SENSITIVITY OF SEISMIC HAZARD RESULTS  
AT MILLSTONE TO LLNL STUDY ASSUMPTIONS  
ON ATTENUATION AND SEISMICITY

FINAL REPORT  
TO  
NORTHEAST UTILITIES

# Dames & Moore

June 15, 1984

Figure 12  
 Hazard Curves for Median and  
 Average of "Best Estimates"

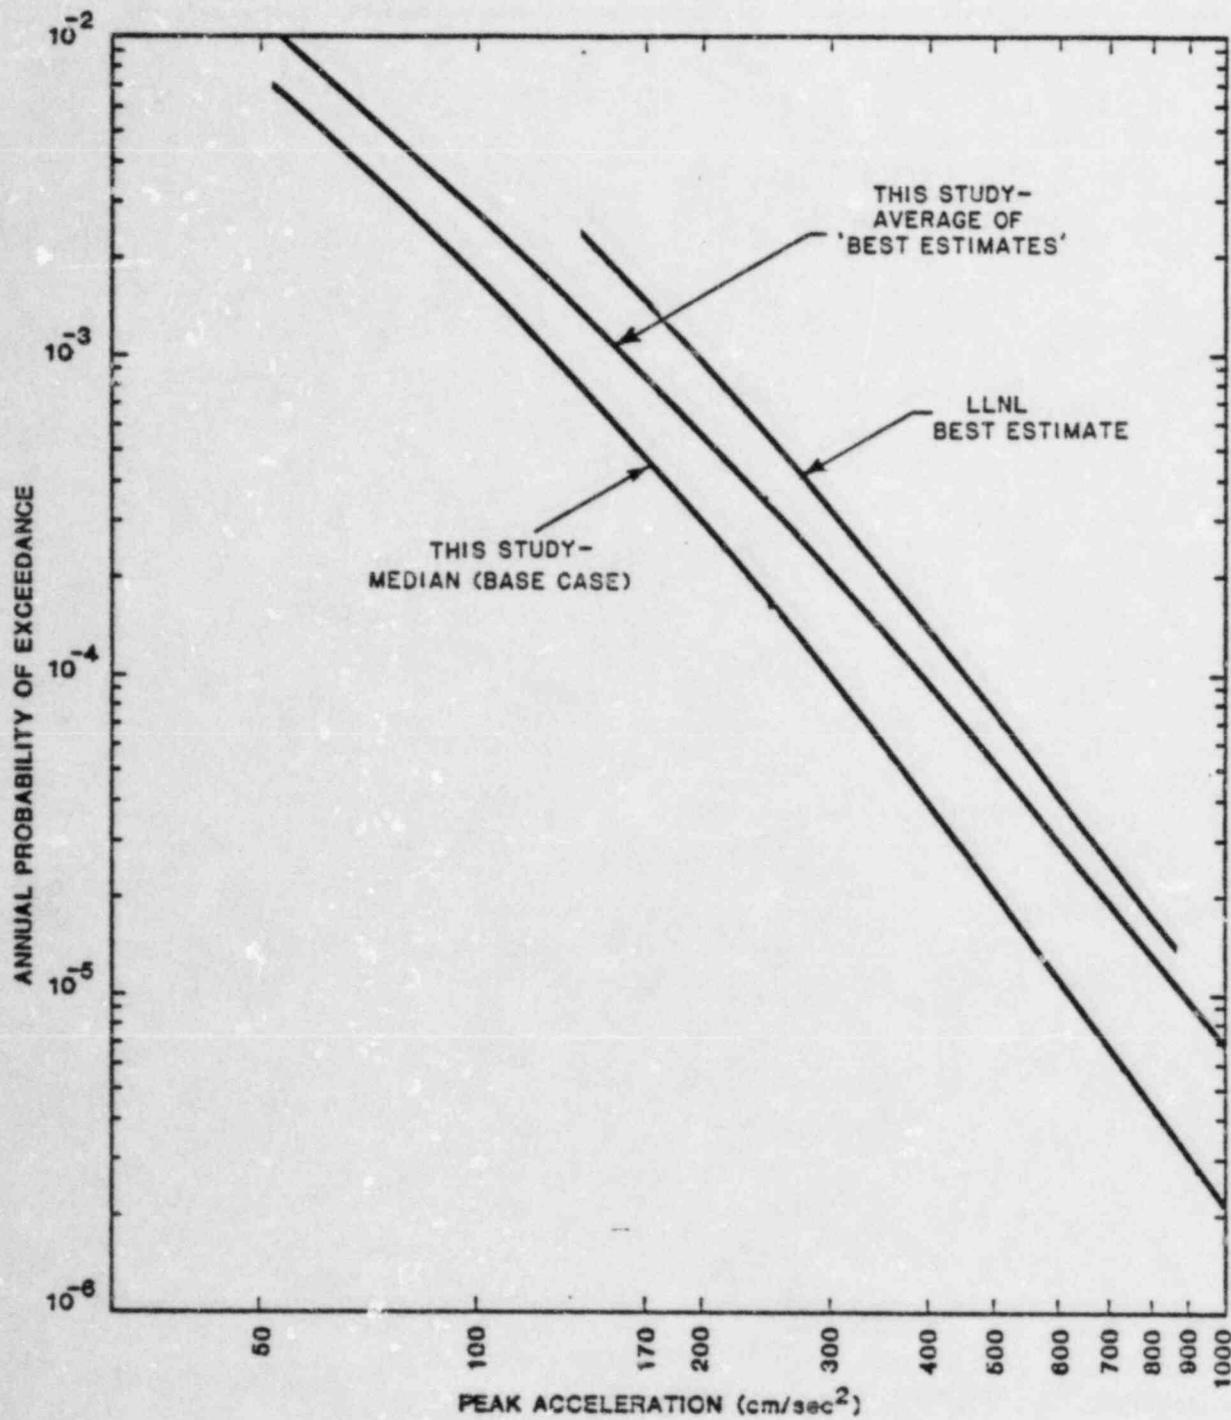
A basic set of results was produced to replicate the LLNL calculations and ensure that no errors in input had been made. This set of results was obtained using the best estimate seismic zones and parameters, and the best estimate attenuation models for acceleration. Two LLNL attenuation experts chose the Nuttli (1983) model, one chose the Campbell (1982) model and one chose the Trifunac (1976) model. The resulting probabilities of exceedance at various acceleration levels for these attenuation models and each seismicity expert were then averaged. The resulting probabilities of exceedance, which LLNL labels the "best estimate" results, are shown in Figure 12 as reported by LLNL (in its Figure MI-1). Our attempt to duplicate these results is also shown in Figure 12 and is labeled "This study - average of best estimates." Our results lie slightly below the LLNL "best estimate" curve because we have not modeled all seismic zones and have elected to use approximate, more efficient calculational procedures, but the two top curves in Figure 12 are generally in reasonable agreement.

Also shown in Figure 12 is our median hazard curve for Millstone, produced using the normalized weights shown in Table 2 for the attenuation functions and weighting all seismicity experts equally. The median curve lies below the average-of-best-estimate curve by a factor of about 0.5 in probability. This indicates, in a loose way, the difference between median and mean results for highly-skewed distributions of probabilities of exceedance. As most of the results in the LLNL study are presented in terms of constant percentile (median and fractile) hazard curves, we use the median curve in Figure 12 as our base

Figure 16  
 Median Acceleration Hazard Curves,  
 Base Case And Results Without Trifunac Attenuation

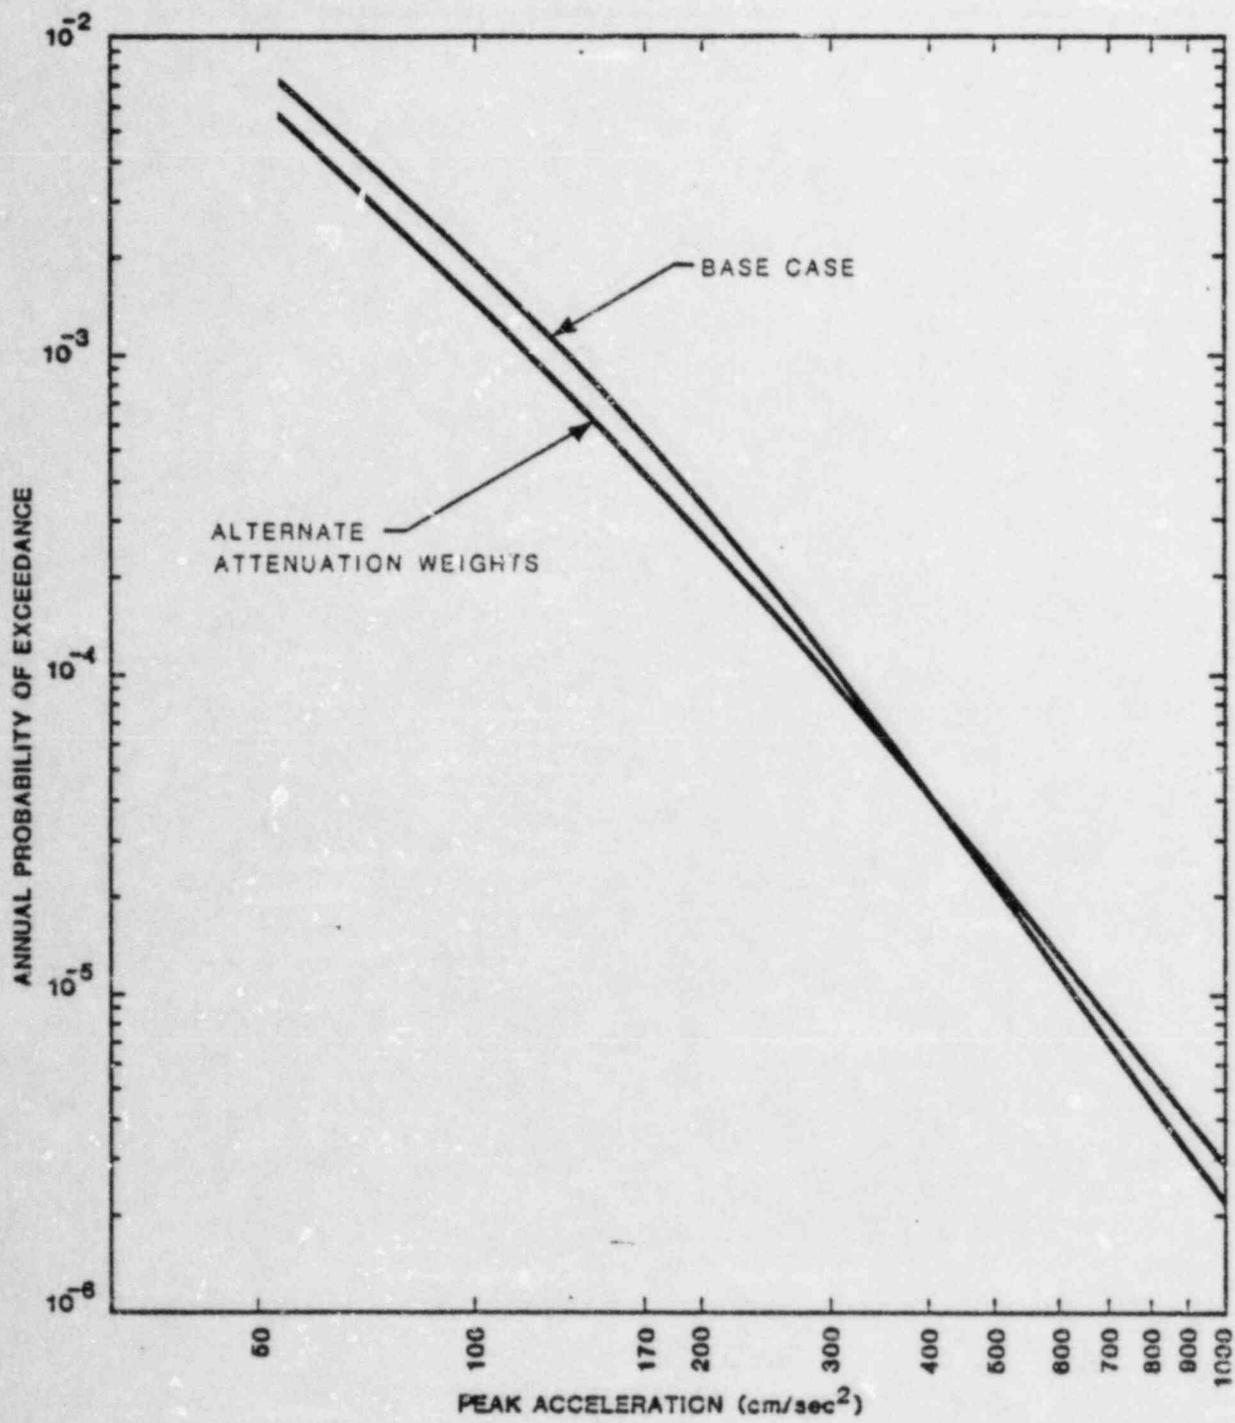
The first effect examined is that of the weights assigned to the attenuation functions. The six attenuation functions are plotted in Figures 13 through 15 for peak ground acceleration and 5% damped spectral velocity at 9 and 5 hz, respectively. The spectral velocity curves labeled RS4 and RS5 were only available at 10 hz, which was considered a close enough approximation to 9 hz to warrant their use. The Trifunac (1976) and Trifunac-Anderson (1977) curves (labeled G16 and RS6, respectively - see Table 2) lie substantially above the others at distances greater than 10 km, for several reasons. Among them is that the original Gupta-Nuttli (1976) intensity attenuation (based on isoseismals) was used, rather than the modified version of this function. A second reason which is particularly important for Millstone is that the form of these equations contains a term  $\exp(cS)$ , where S is a variable indicating soil conditions (0 for soft soils, 1 for medium soils, 2 for rock). Most of the data on which the calibration was based was for conditions 0 and 1, so the use of the equation for rock sites ( $S = 2$ ) constitutes an extrapolation based on the functional form of the equation, rather than on data. Moreover, the most recent attenuation equations in California indicate little effect of soil conditions on peak acceleration. The Trifunac form might be more acceptable if the intensity attenuation equation with which it is used was based on intensity values at rock sites (not on isoseismals drawn for all sites including high intensity, soft soil conditions as usually exist in towns located in river valleys) but this has not been done. A justifiable alternative is to drop the Trifunac (1976) and Trifunac-Anderson (1977) curves from the analysis on the basis that they are overly conservative for a mean-centered analysis.

To accomplish this, we used the "alternative normalized weights" shown in Table 2 to weight the remaining five attenuation functions. This has the effect of removing the Trifunac equations from the analysis and redistributing its weight among the other five attenuation functions.

The resulting median hazard curve for peak acceleration is shown in Figure 16. The change in hazard varies with acceleration level: at the SSE level ( $170 \text{ cm/sec}^2$ ) the probability at a given acceleration level decreases by about 25% and the acceleration at a given probability level decreases by about 10%. For a typical slope of the hazard curve these two changes are related by:

For example,  $(.90) = (.75) \cdot .375$ . At high accelerations the alternate weights imply a slightly higher hazard than the base case.

Figure 17

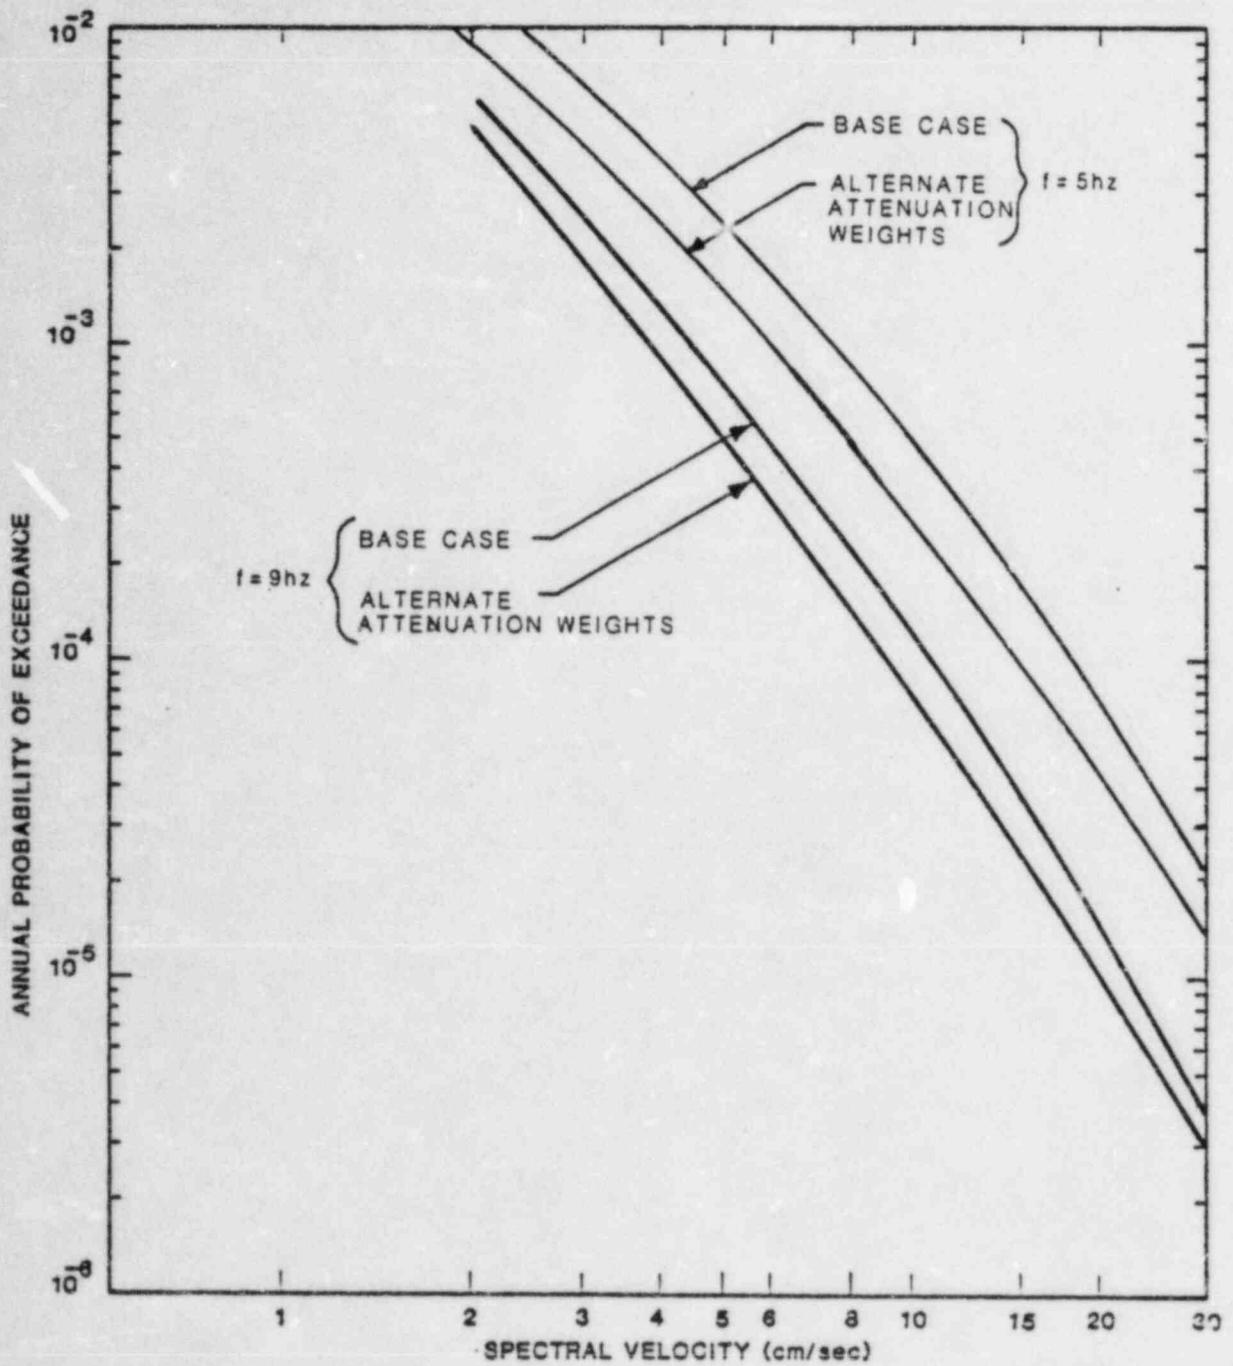
Figure 17 shows equivalent results for spectral velocities at 9 hz and 5 hz. Here the effect of alternate attenuation weights is larger: at 10 cm/sec, spectral velocities decrease by about 40% in probability or 17% in spectral velocity. We conclude that the effects of attenuation functions on spectral velocities are not necessarily well-estimated by comparisons based on ground acceleration. The reason is related in part to the larger range in estimates for spectral velocity than for peak acceleration (compare  $m_b = 5.0$  at 20 km in Figure 13 to Figures 14 and 15).
